Seismic Walkdown Checklist (SWC)

Peach Bottom Atomic Power Station Unit 2
MPR-3815, Revision 3
Correspondence No. RS-12-173

Equipment ID No. 20P033, 20P038 & 20S037 ^{KG 9/11/2012} ~~KG 9/11/2012~~ Equip. Class¹² (05) Horizontal Pumps

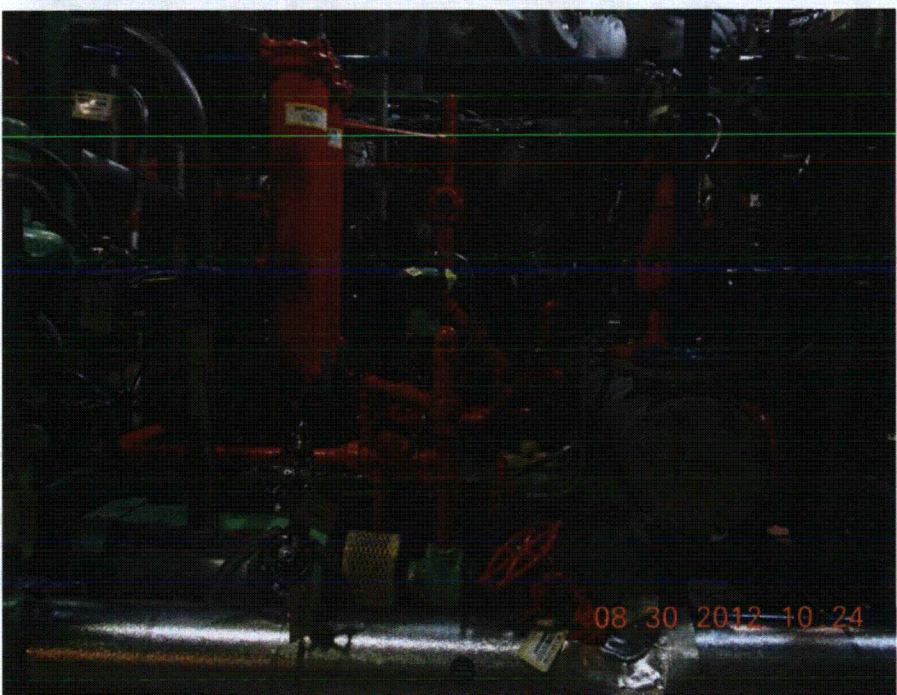
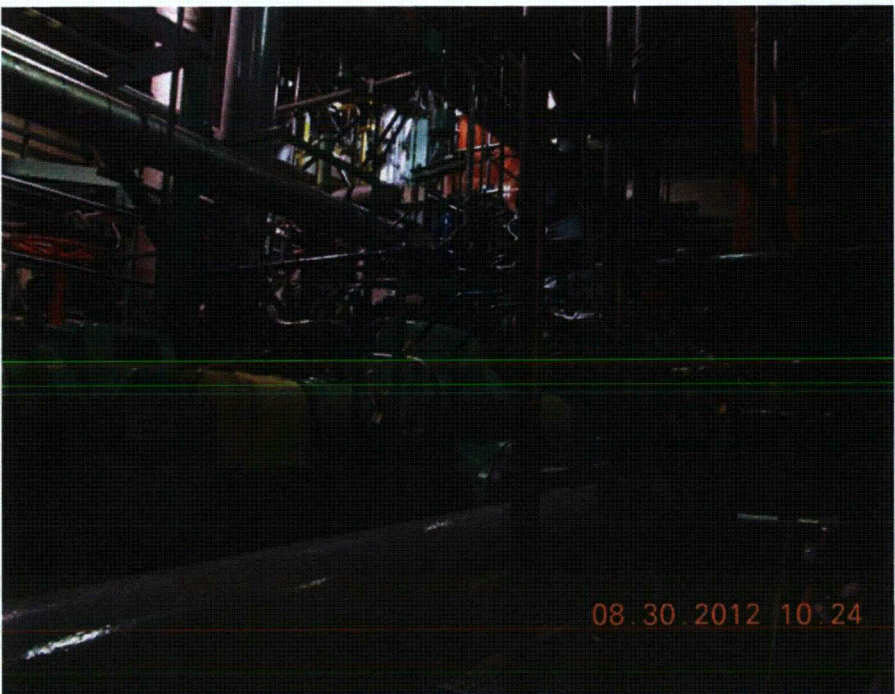
Crane controller not secured (coiled on pump pedestal), not a credible threat to pump or other area SSCs; can't actuate, not plugged in

Equipment ID No. 20P036 & 20S038 Equip. Class¹² (05) Horizontal Pumps

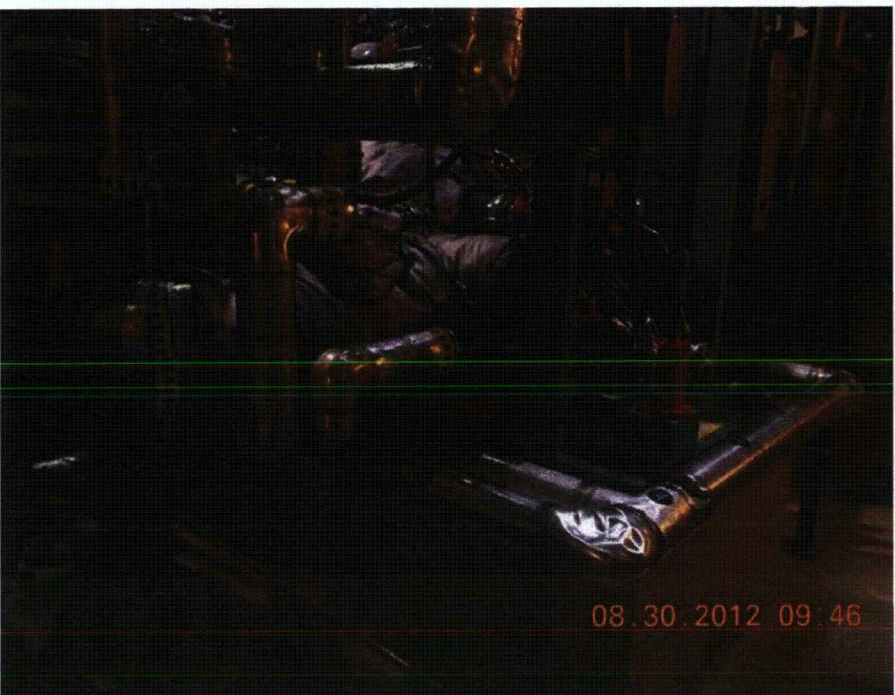
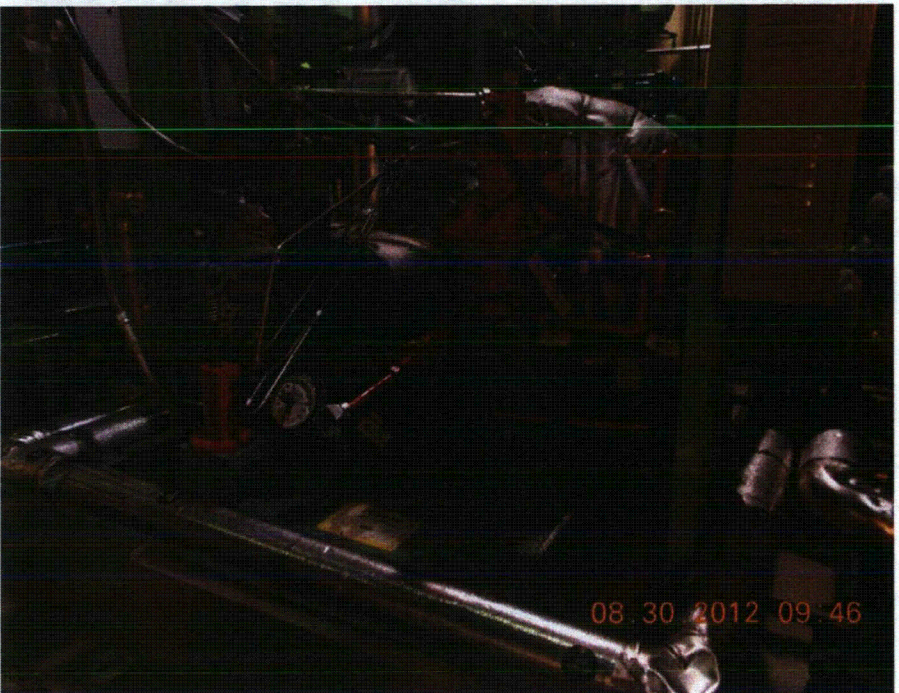
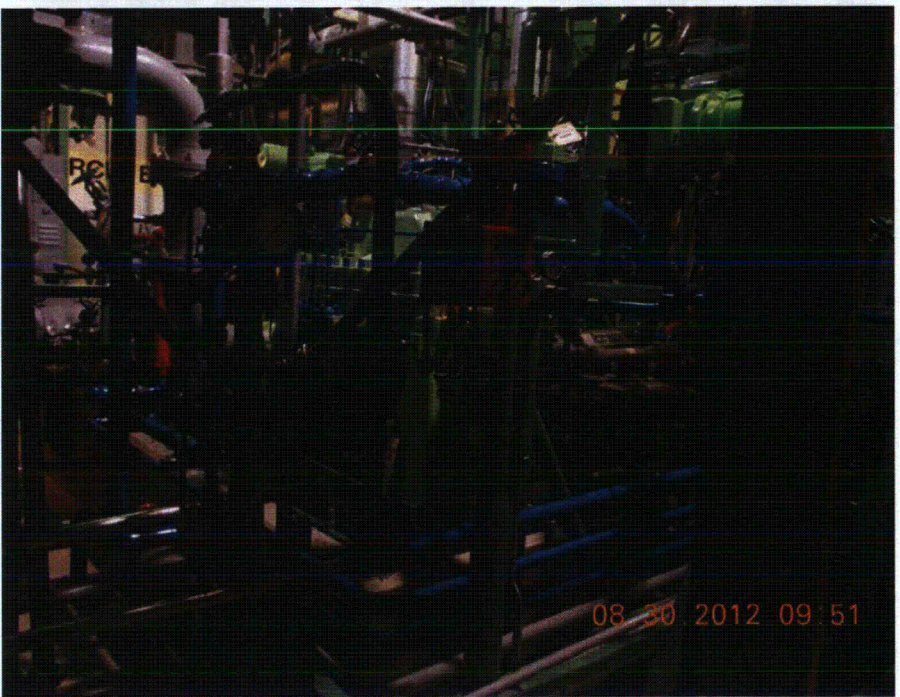
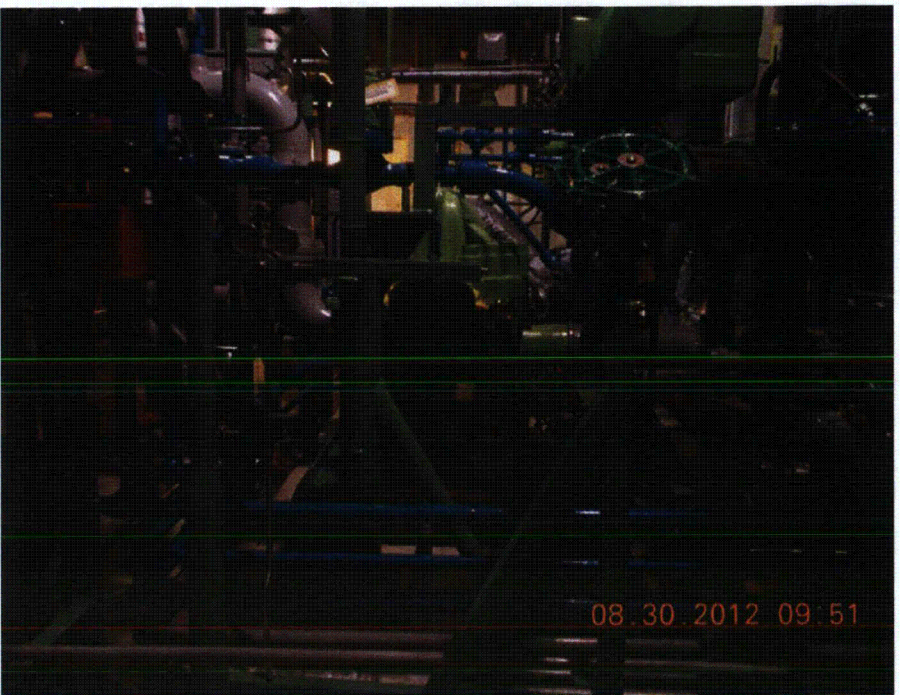
Temporary crane chained to area free of other SSCs

Equipment ID: 20X033

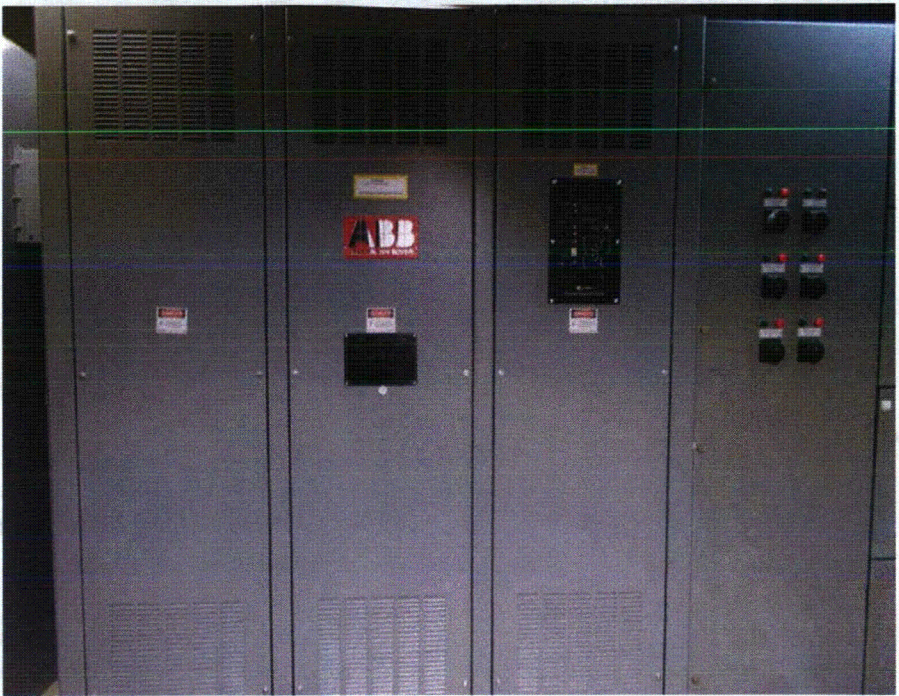
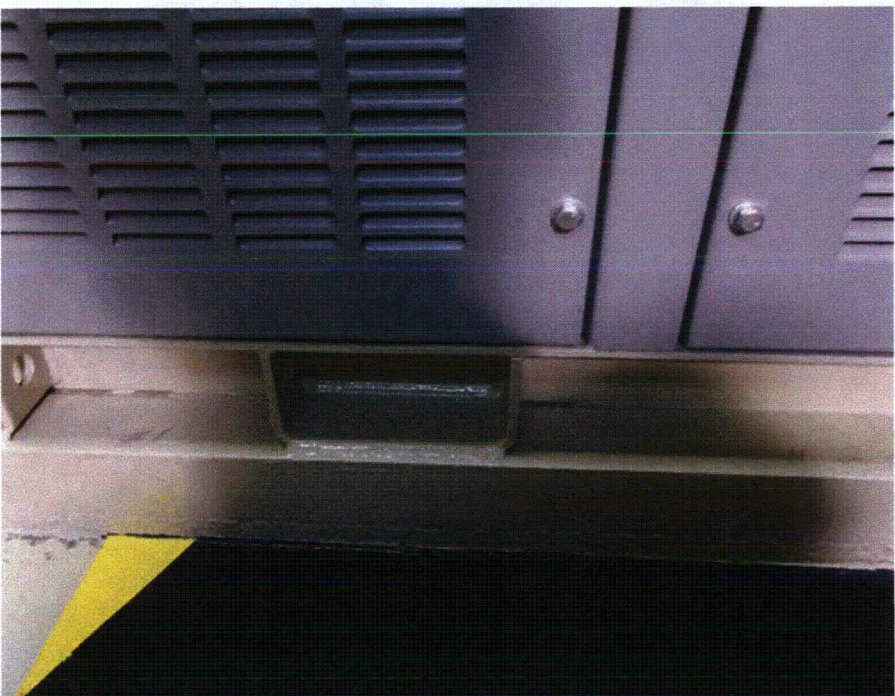
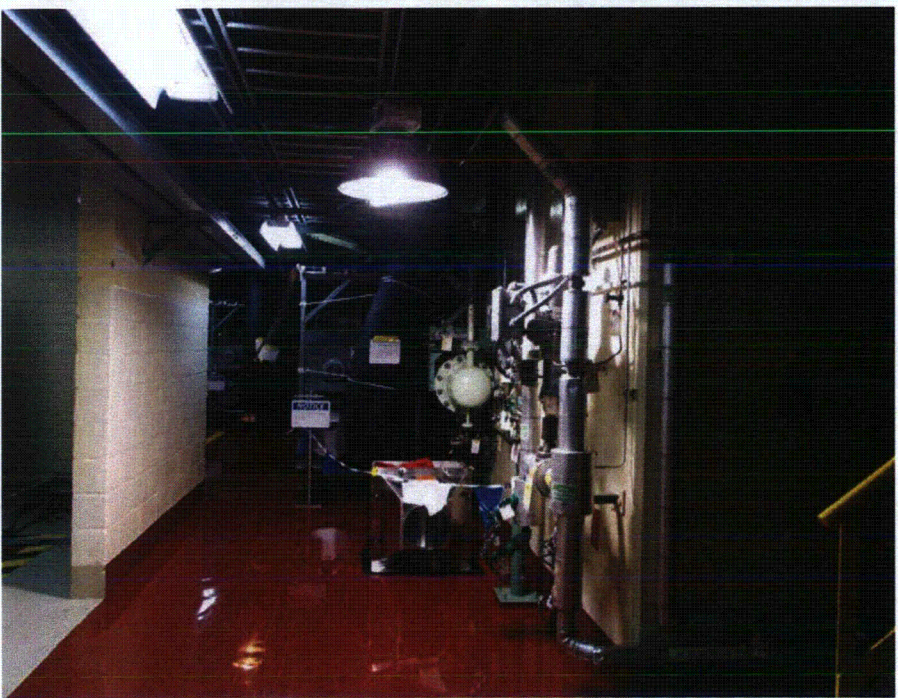
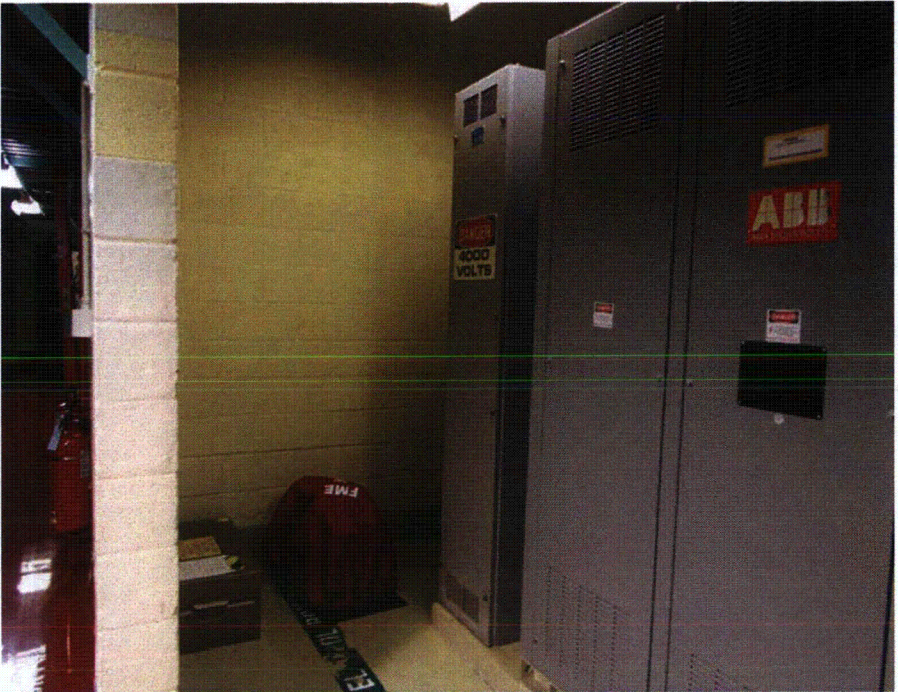
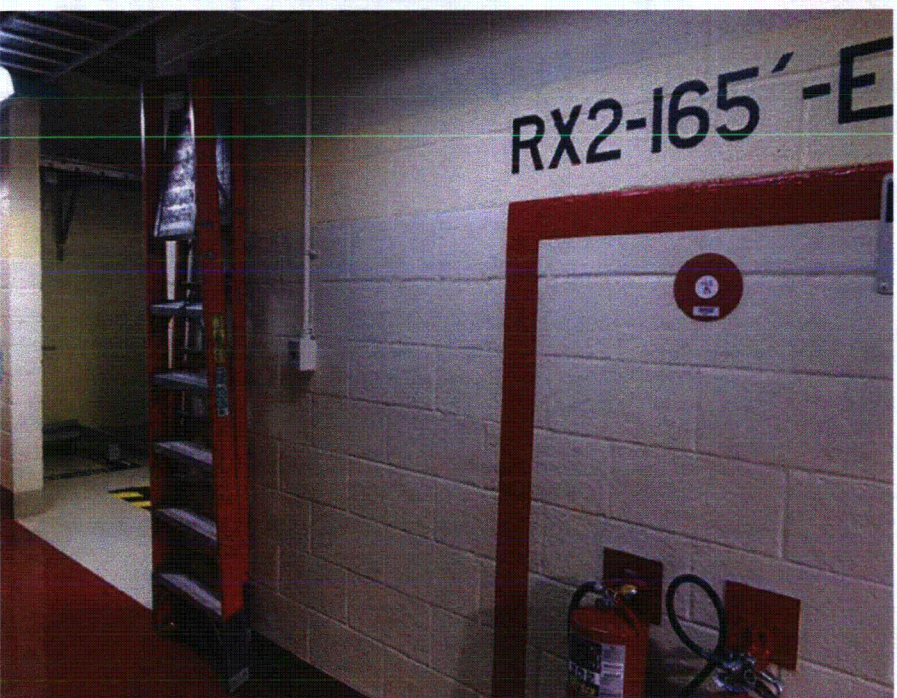
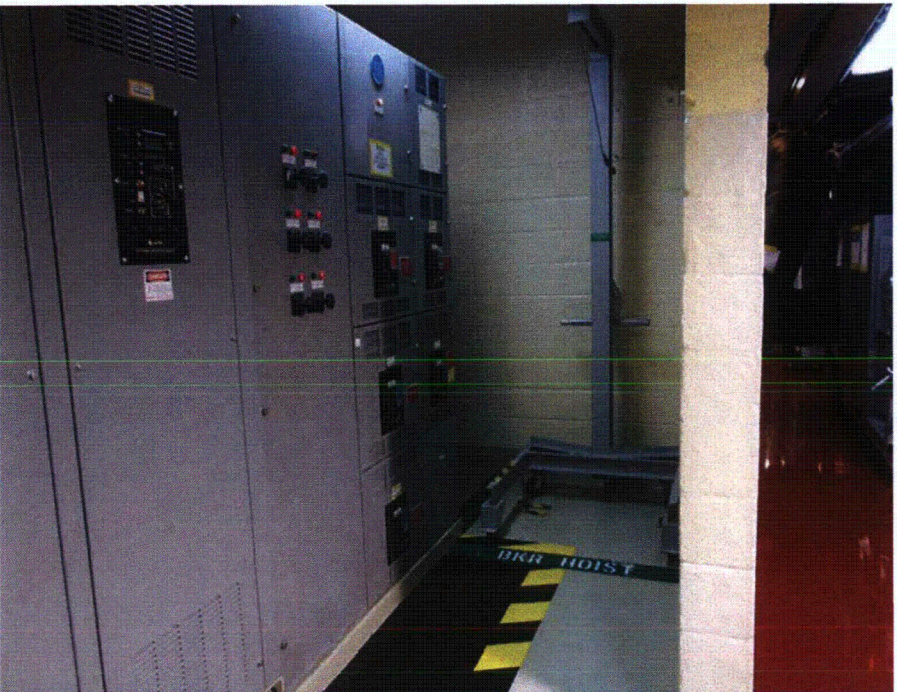
*Flourescent light fixtures - all observed S-hooks are closed.
masonry block walls - see below.
Damage from falling light bulbs not credible.*

*Masonry walls located on north, west, and ^{south.} east of component.
East wall is poured in place. ^{BMF 8/31/12}
IPEEE - Confirmed transformer is ABB type and properly anchored. ^{per PBAPS drawing S-76 Revision 4.}
Component surrounded by block walls 76-6, 76-8, 76-9, and 76-10. These walls are safety related per PBAPS specification M-70, Revision 1.*
